CREEKWOOD SUBDIVISION, UNIT III

APPLICATION NUMBER 31 DATE January 3, 2008

REQUEST Subdivision

DETAIL SITE PLAN

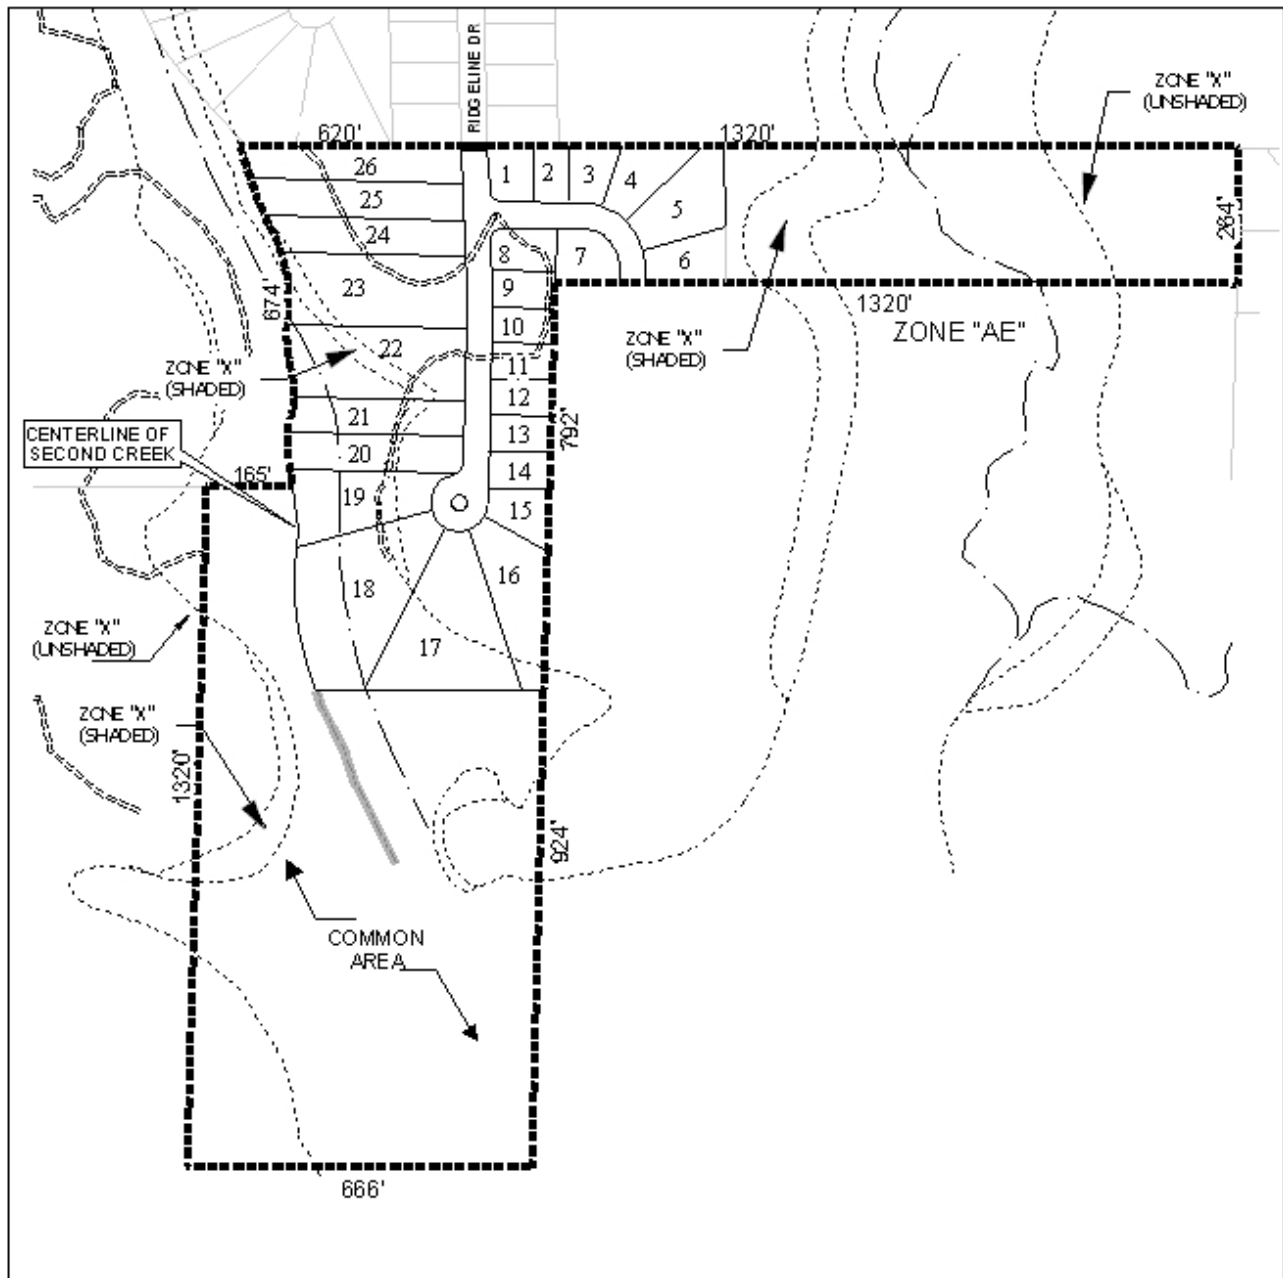
The plat illustrates the proposed 26-lot, 36.0± acres subdivision which is located at the South terminus of Ridgeline Drive. The subdivision, which is located outside the Mobile City Limits, is served by public water and sanitary sewer.

The cul-de-sac at the South terminus of Ridgeline Drive is proposed to have a central median. The site is within the Mobile Fire-Rescue Jurisdiction, and with its recent adoption of the 2003 International Fire Code Standards, a cul-de-sac with a central median requires a 140' diameter. Although not specified on the plat, the cul-de-sac scales at 110' diameter; therefore, the cul-de-sac should be revised to be 140' diameter. Also, the proposed dead-end street stub off the East side of Ridgeline Drive will require a turnaround; therefore, a turnaround approved by the Mobile Fire-Rescue Department should be indicated on the plat.

The site abuts multiple land-locked parcels on the East side of the site. The Subdivision Regulations require that street stubs be provided to adjacent land-locked areas. However, it

should be pointed out that the general vicinity, including parts of the site, are fraught with floodplain and wetland issues associated with branches of Second Creek. These issues, along with topography, will make access to some of the adjacent parcels from the site in question difficult. The portion of the over-all site proposed to be developed with this application abuts three land-locked parcels on the East side. One of the parcels is afforded access via the street sub on the East side of Ridgeline Drive. The two other parcels immediately to the South are not afforded any access; therefore, the plat should be revised to afford access to these two parcels, also.

All proposed lots appear to meet minimum dimensional requirements; however Lots 17 through 23 appear to have just over half the lot encumbered by floodplain for a branch of Second Creek. Several lots also appear to be impacted by the floodway associated with Second Creek. Several of the lots exceed the depth-to-width ratio of Section V.D.3. of the Subdivision Regulations; however, other lots have been recorded in Unit II of a similar nature.

No access is provided to the “common area” South of the area proposed to be developed with this application; therefore, the plat should be revised to provide access to this area from Ridgeline Drive.

Stormwater facilities are not depicted on the plat, however, compliance with the City of Mobile stormwater and flood control ordinances will be required. A letter from a licensed engineer certifying compliance with the City’s stormwater and flood control ordinances should be submitted to the Planning Section of Urban Development prior to the signing of the final plat, if approved.

Any detention basins should be labeled as common areas on the plat. A note should be placed on the final plat, if approved, stating that maintenance of any detention basin common areas, and any other common areas, are the responsibility of the subdivision’s property owners.

The 25' minimum building setback line, required in Section V.D.9., is not shown on the plat, but would be required on the final plat, if approved.

The plat labeled each lot with its size in square feet. This should also be done on the final plat, or a table should be provided depicting the same information.

1. revision of the plat and legal description to remove Parcel #R023303062000003.001, which is a part of the approved Cypress Cove Subdivision;
2. revision of the cu-de-sac at the South terminus of Ridgeline Drive to be 140' diameter as per the 2003 International Fire Code Standards;

3. revision of the plat to include a turnaround at the South terminus of the street stub off the East side of Ridgeline Drive, to be approved by Mobile Fire-Rescue Department;

4. revision of the plat to afford street access to the two land-locked parcels (R023303061000004 and R023303061000004.01) on the East side of the area proposed to be developed;

5. provision of access from Ridgeline Drive to the "common area" South of the area proposed to be developed;
6. placement of a note on the plat stating that approval of all applicable federal, state and local agencies is required prior to the issuance of any permits or land disturbance activities;

7. provision of a flood study, if deemed appropriate for compliance with FEMA regulations;
8. placement of a note on the plat stating that approval of all applicable Federal, state and local agencies is required for endangered, threatened or otherwise protected species, if any, prior to the issuance of any permits or land disturbance activities;

9. provision of a certification letter from a licensed engineer to the Planning Section of urban Development, certifying that stormwater detention, drainage facilities, and release rate comply with the City of Mobile stormwater and flood control ordinances, prior to the signing and recording of the final plat;

10. labeling of all common areas, including any detention basins, and placement of a note on the final plat stating that maintenance of the common areas is the responsibility of the subdivision's property owners;

11. depiction of the 25' minimum building setback line;
12. labeling of each lot with its size in square feet, or the provision of a table depicting the same information;

13. verification that sufficient buildable area shall be provided for each lot (particularly lots 18 through 22); and
14. placement of a note on the Final Plat stating that any lots which are developed commercially and adjoin residentially developed property must provide a buffer, in compliance with Section V.A.7. of the Subdivision Regulations.
